In-vehicle battery durability e-HDVs

Open Items

Elena Paffumi, Gian-Luca Patrone
EVE IWG 74th, Tokyo, Japan,
EVE IWG 75TH

September 18th-19th, 2024

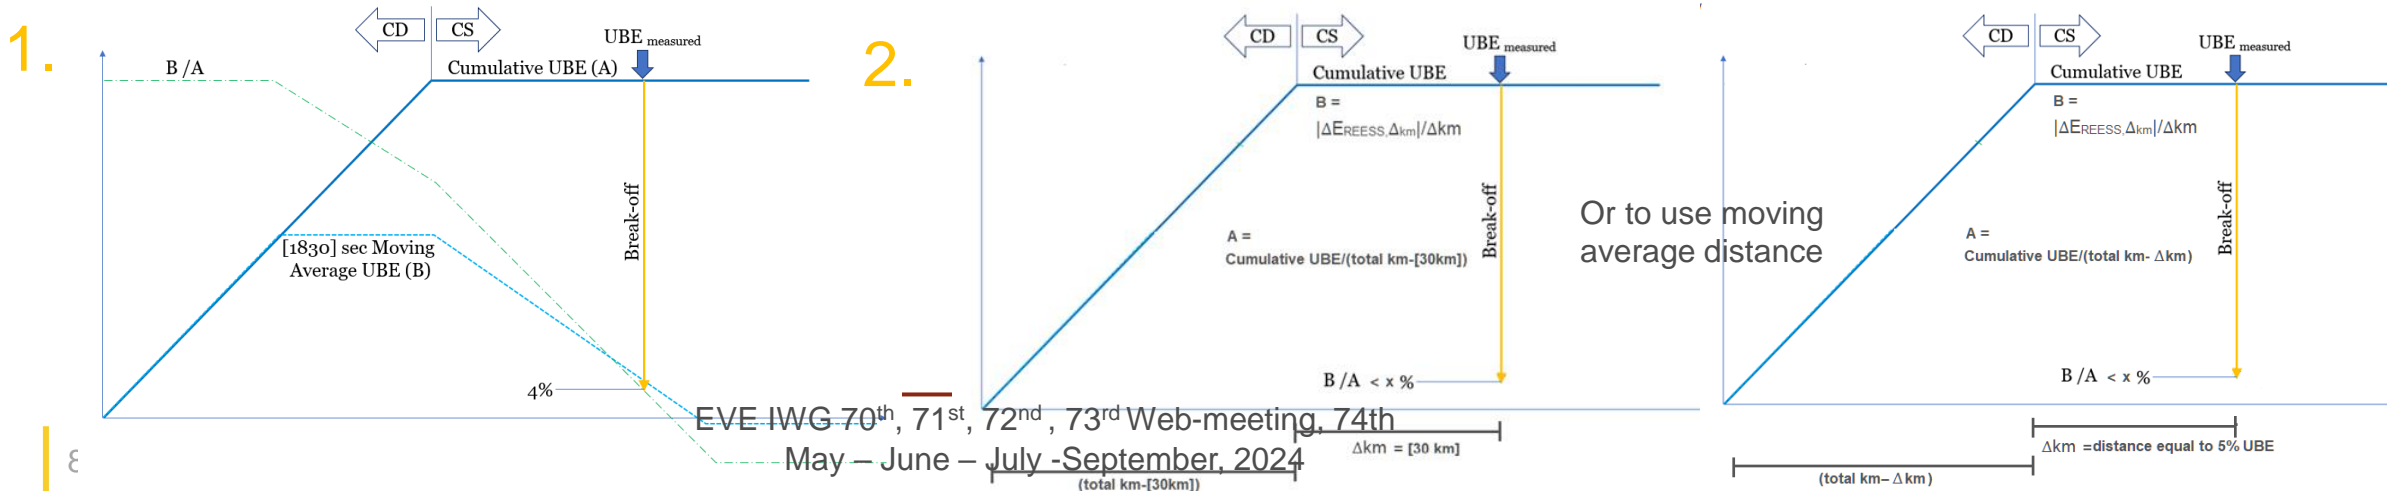
Japan: at least 1500sec ?
JE05 : 1830 sec
WLTP 4 : 1800 sec
WLTP 3 : 1477 sec

Japan: 4 per cent of cumulative UBE

30 km ? → Percentage of UBE (5%) instead of km

2-3-5 per cent ?

Method 1a Discharge by standard average speed on a test track

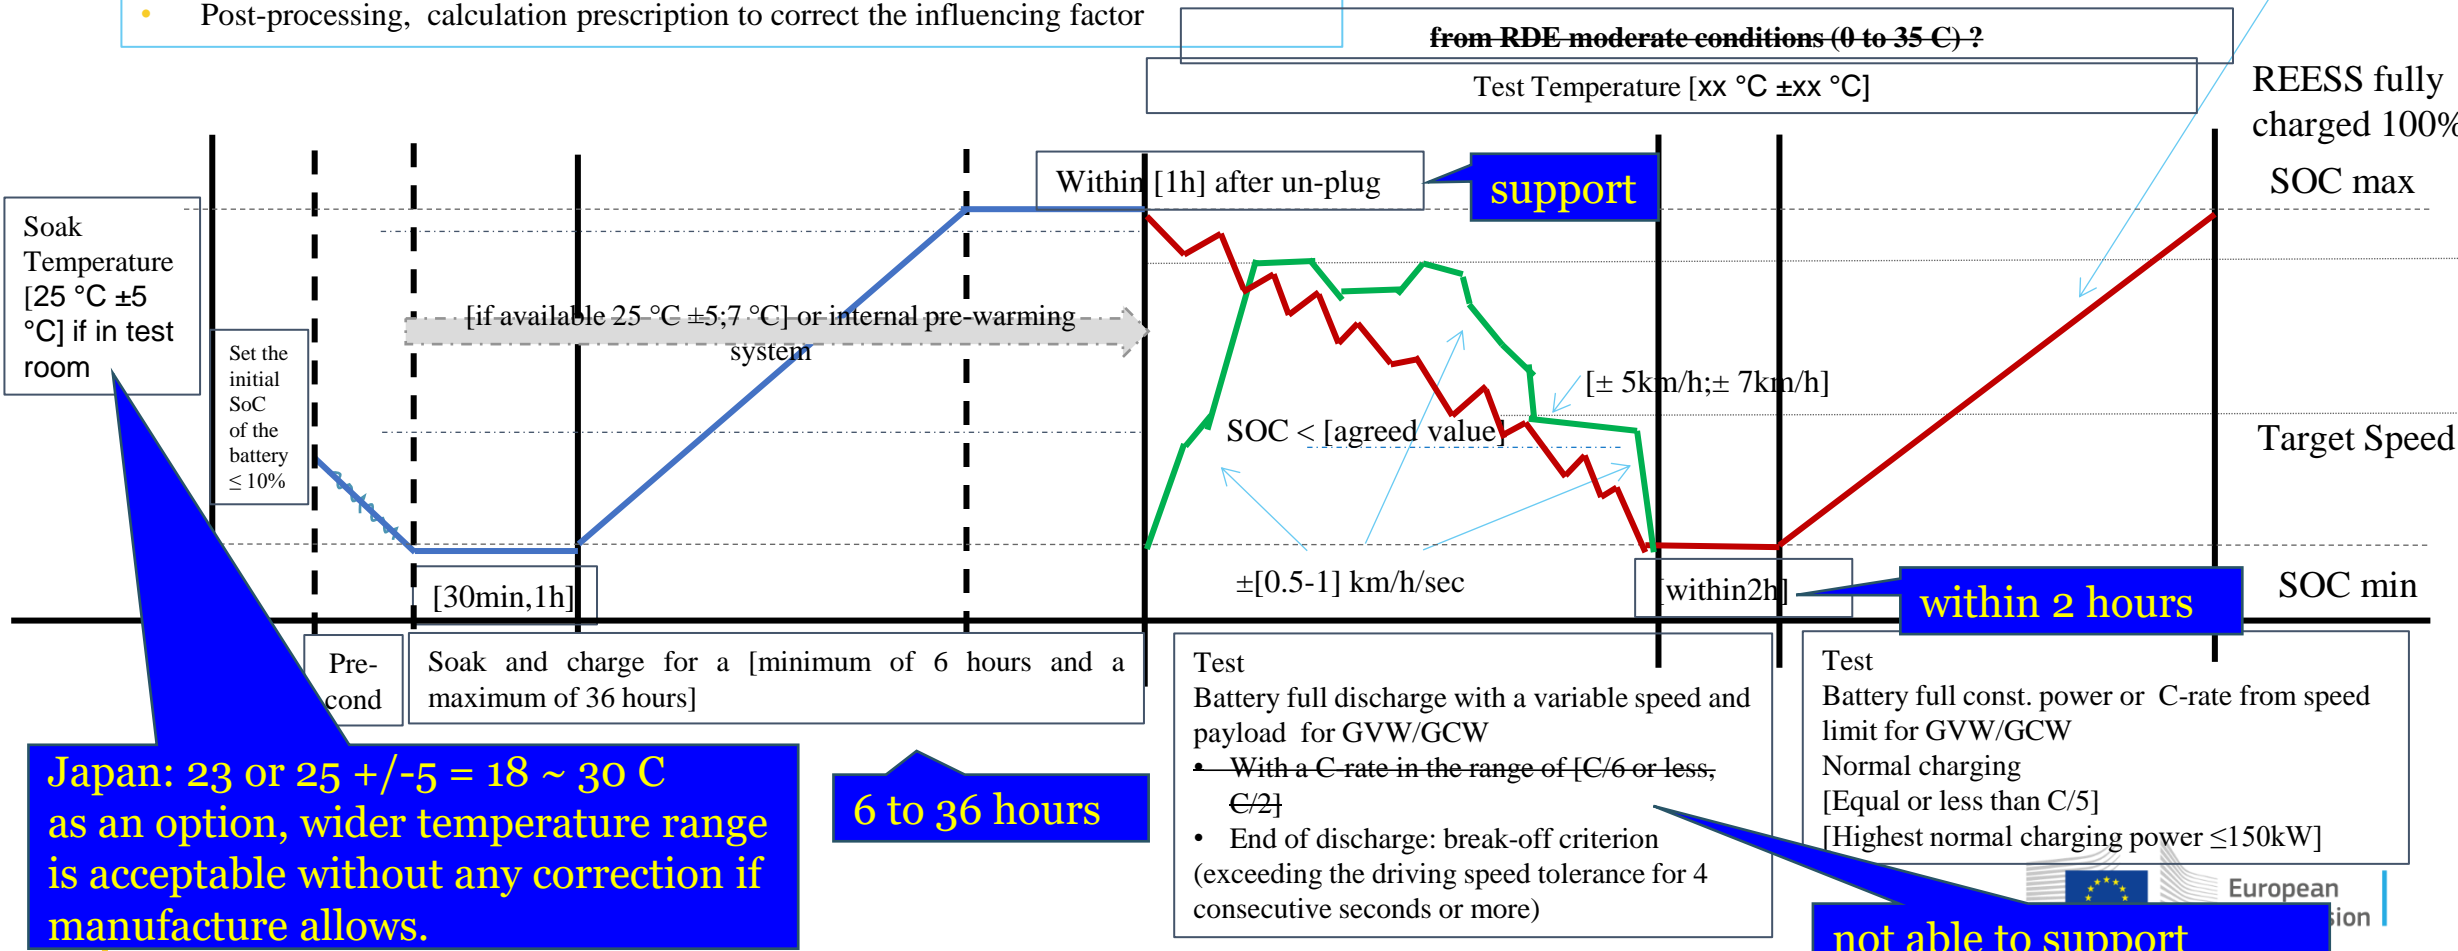
from RDE moderate conditions (0 to 35 C)?

Japan: 23 or $25 \pm 5 = 18 \sim 30\text{ }^\circ\text{C}$ as an option, wider temperature range is acceptable without any correction if manufacture allows.

not able to support

Method 2 bidirectional charging system available

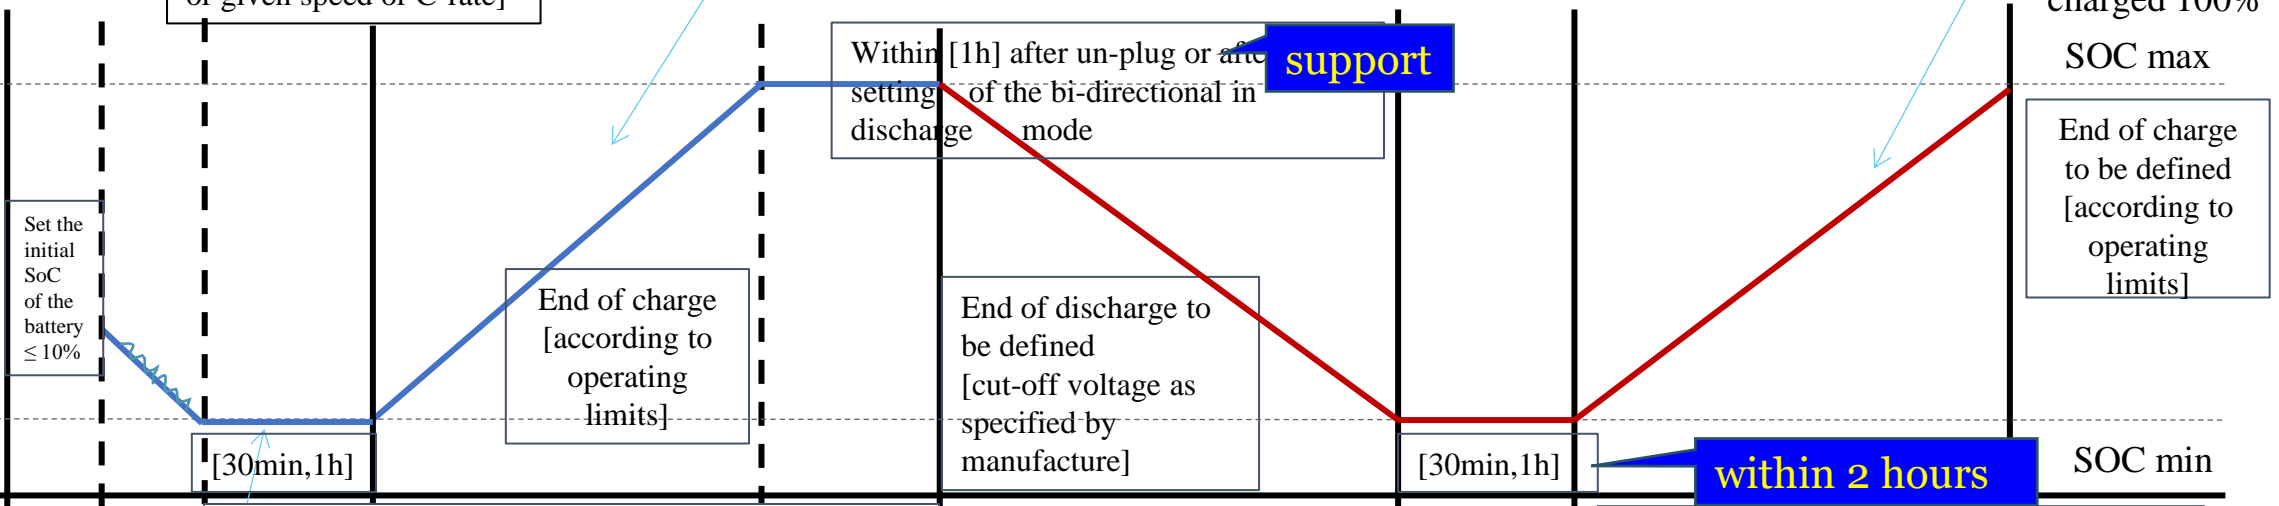
Japan: 23 or 25 +/- 5 = 18 ~ 30 C as an option, wider temperature range is acceptable without any correction if manufacture allows.

within 0 ~ 35 C

follow manufacture recommendation

not able to support
